FOR KELANITISSA GAS TURBINE PROJECT

BID NO.: CEB/KGTP/PROC/01/Re

ADDENDUM 1

KELANITISSA GAS TURBINE PROJECT

Terminal Points of KGTP - Appendix G3

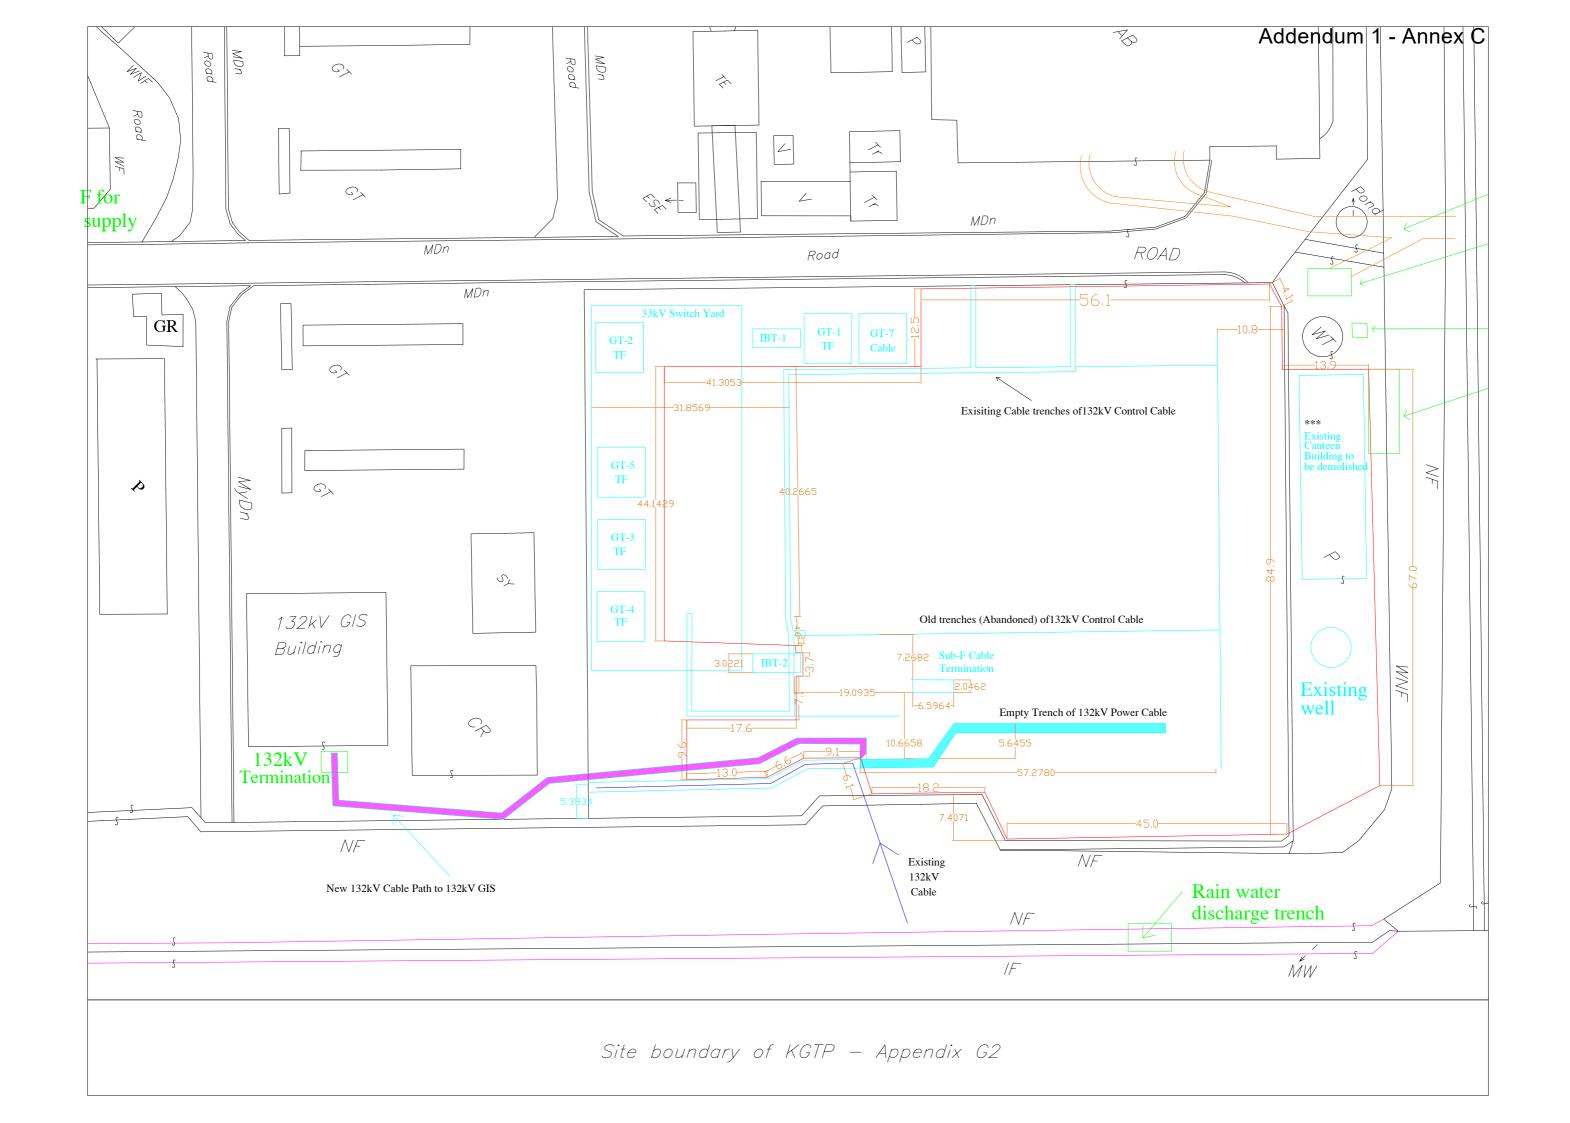
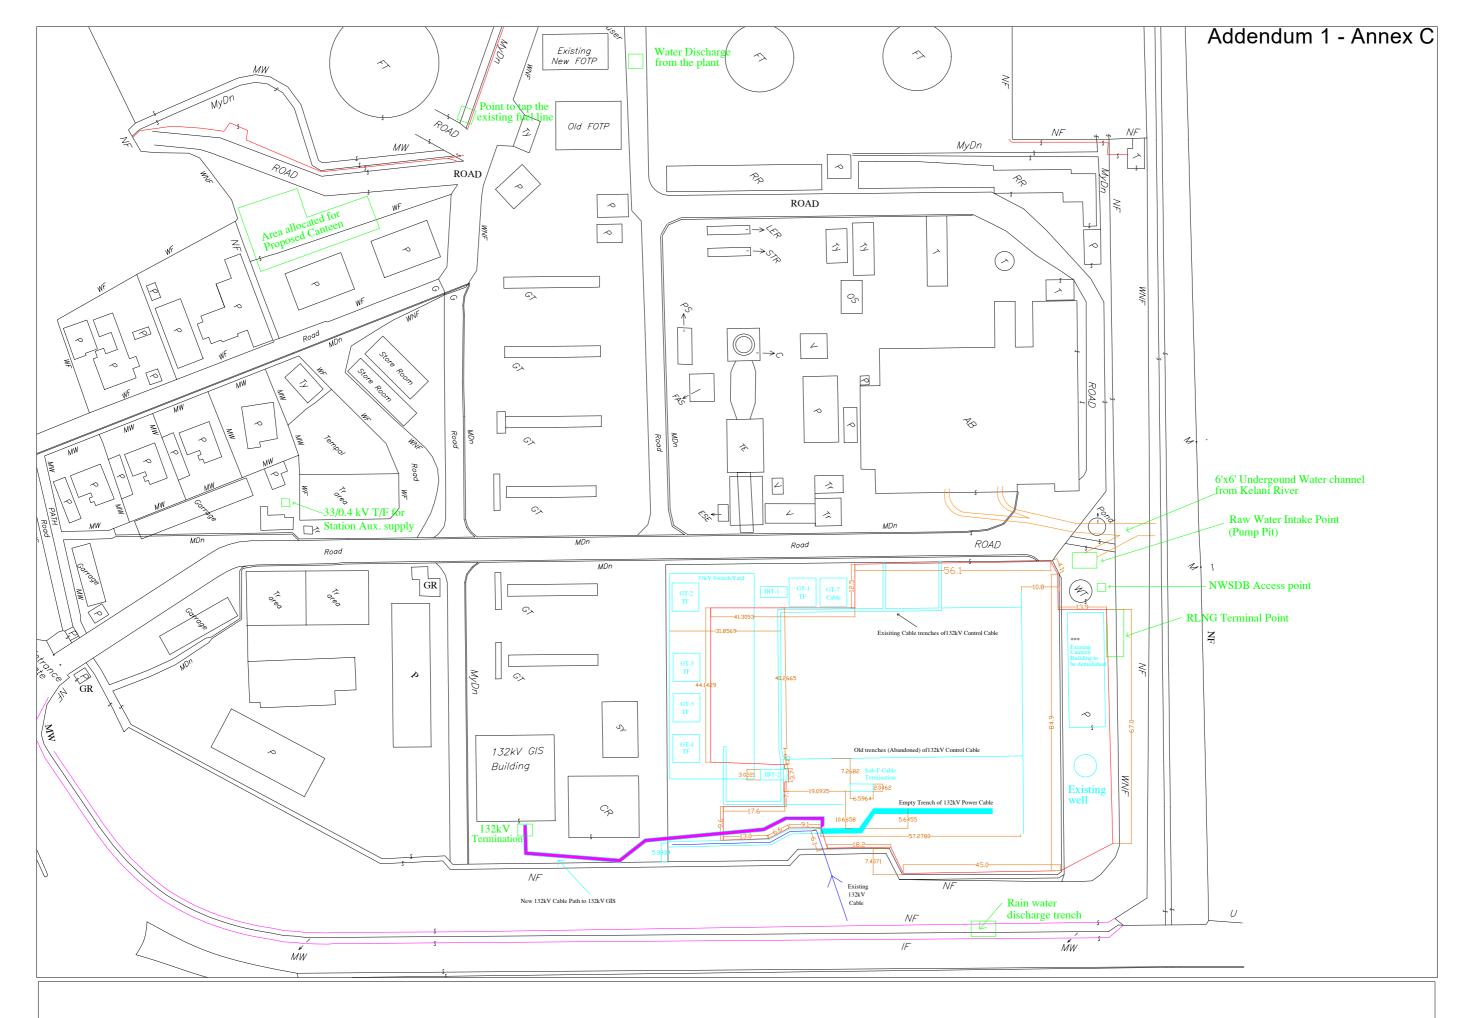
Annexure G of Volume 3: Site Layout

Appendix G1, G2 and G3 indicating all terminal points are annexed as *Annex C* to the addendum 01.
